UNITED STATES PATENT AND TRADEMARK OFFICE

APPLICATION NO.	FILING DATE	FIRST NAMED INVENTOR	ATTORNEY DOCKET NO.	CONFIRMATION NO.
10/617,171	07/11/2003	Ki-Tag Jeong	1293.1902	2998

Final Rejection

FIG. 8 Prior Art

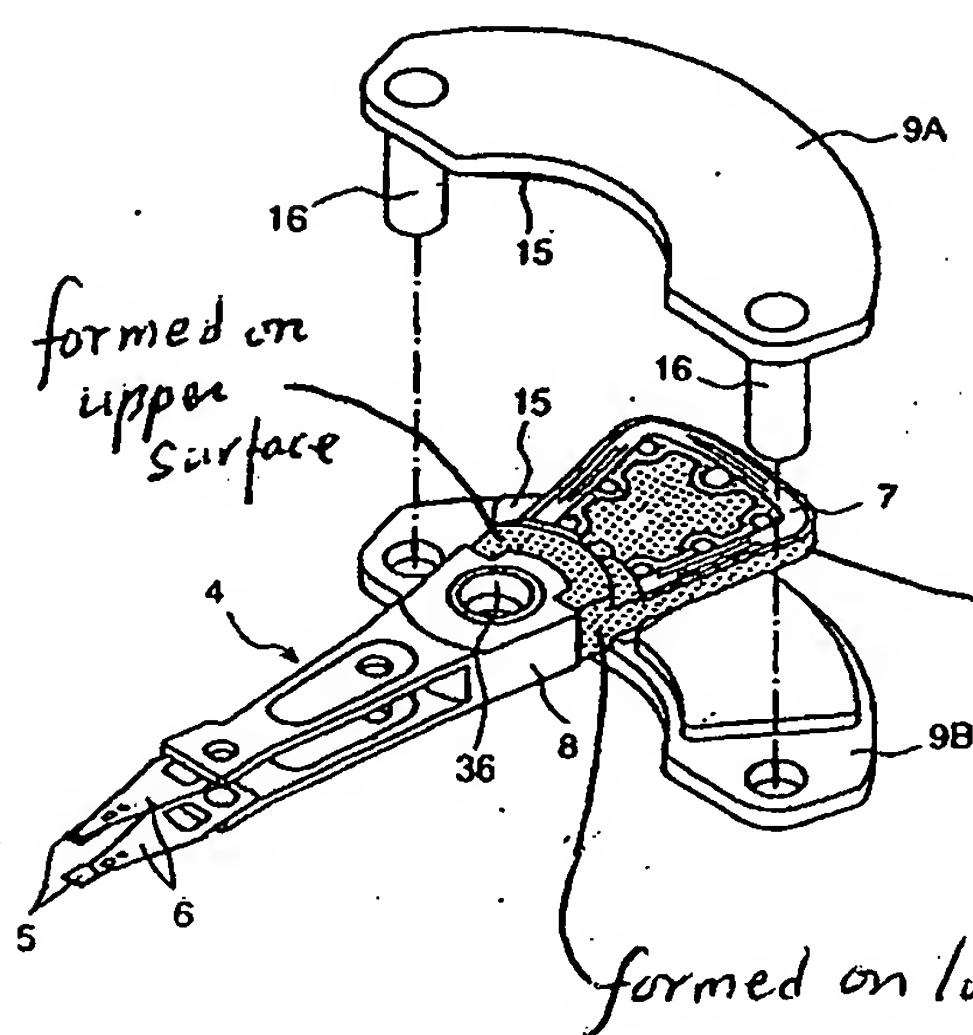
Claims 1, 5, 6, 10, 11, 15, 16, and 20; Takashima shows an actuator of a hard disk drive in Fig. 1, having a base plate and a voice coil motor, to move a magnetic head to record and reproduce data with respect to a disk to a predetermined position on the disk, including: and Fig. 8 shows a suspension 6 supporting a slider 5, where the magnetic head is mounted; and an arm 8 included on the base plate of the hard disk drive to pivot, the arm including the suspension at a leading end portion of the arm and a coil 7 (Fig. 8) of the voice coil motor coupled to a rear end portion of the arm, wherein the coil is coupled to the rear end portion of the arm by an outer mold (See Figs. 8 and 9 with added marks in next page) formed to encompass an outer circumference of the coil, an inner mold formed inside the coil, and a connection mold connecting the outer mold and the inner mold is formed at least part of a surface of a non-effective portion of the coil except for an effective portion arranged to be perpendicular to a direction in which the arm pivots.

FIG. 9 Prior Art

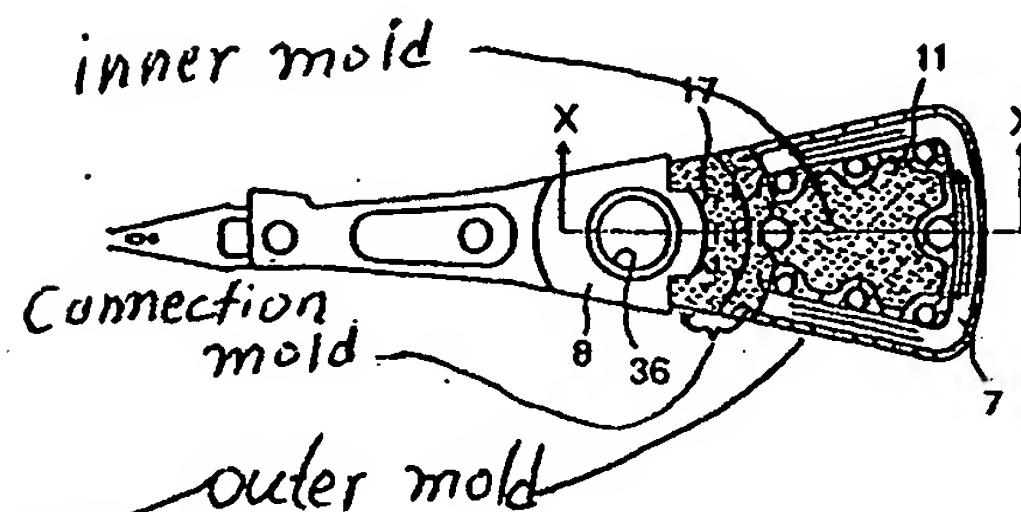
Claim 6, Takashima also shows a hard disk drive that reproduces data stored in a disk or records data on the disk by using a magnetic head, the hard disk drive including: an actuator including an arm included on a base plate of the hard disk drive to pivot and a suspension at a leading end portion of the arm and supporting a slider on which the magnetic head is mounted; and a voice coil motor including a coil coupled to a rear end portion of the arm and a magnet arranged, which is inherently separated a predetermined distance from the coil and to face at least one of upper and lower surfaces of the coil, and pivoting the actuator in a predetermined direction by the interaction between current flowing through the coil and a magnetic field formed by the magnet.

FIG. 10 Prior Art

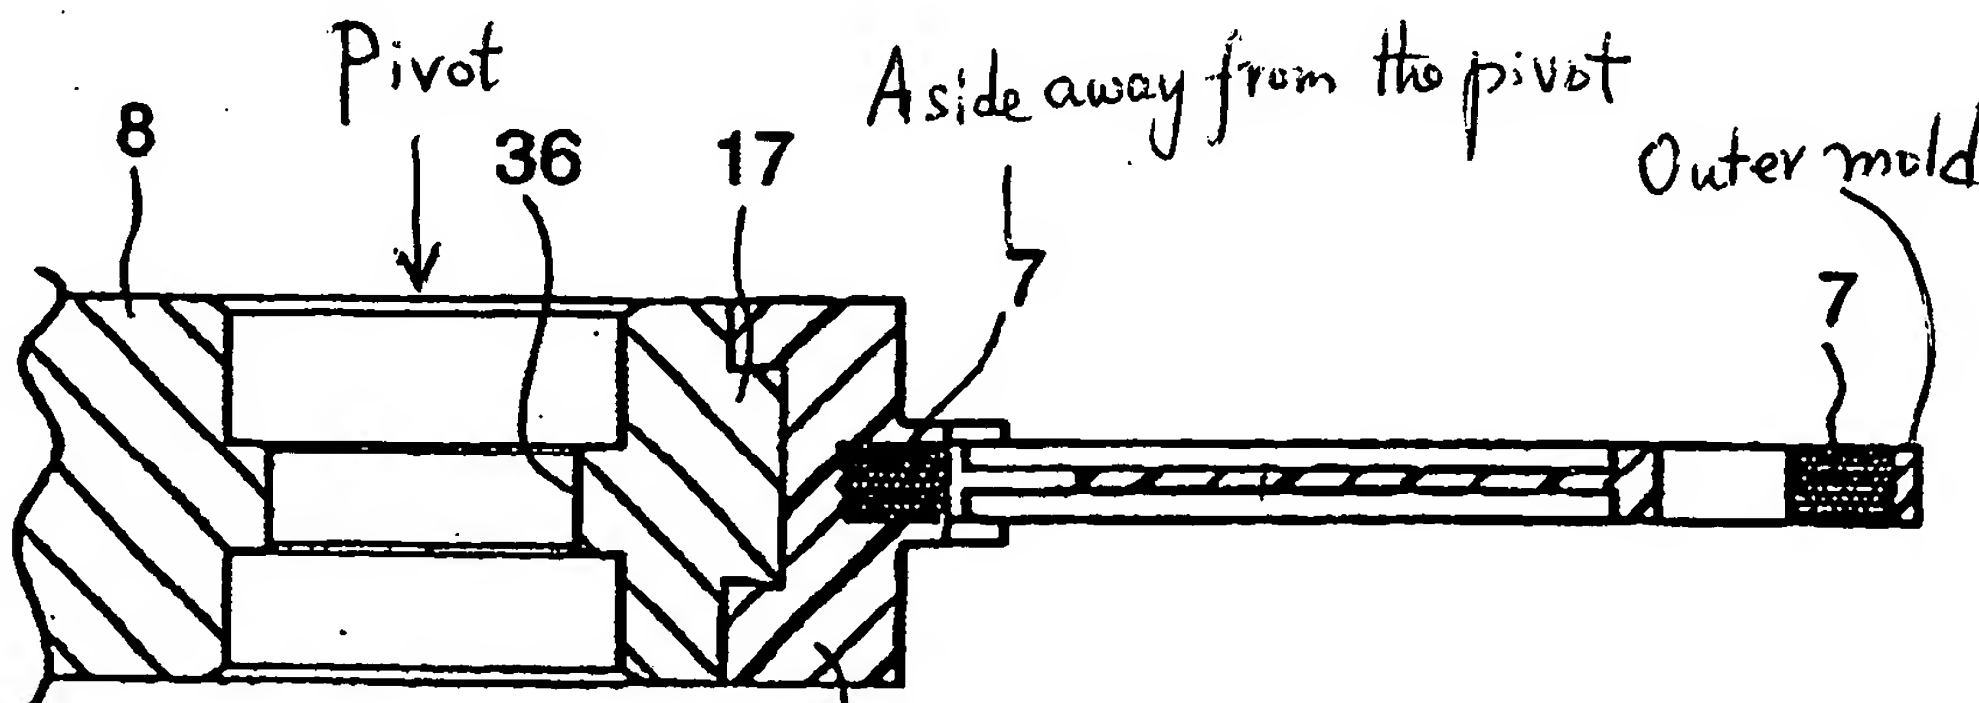
Claim 23, Takashima further shows in Fig. 10 attached in next page that the arm has a pivot, the coil has a side away from the pivot and the connection mold is located on the side away from the pivot.

Applicant argues: "Figure 10 is cross-sectional view of Fig. 9. In Figure 10, the alleged 'outer mold' is the same pad as holding member 11 as the thin/thick stripes of the cross section show. That is, the alleged inner mold 11 is the same piece as the alleged outer mold. In this context, something is missing, either the inner or outer mold."

Examiner's answer: Applicant misreads the figure. The correct way of reading Figure 10 is as follow:

Since Applicant's reading is incorrect, Applicant's argument is moot.
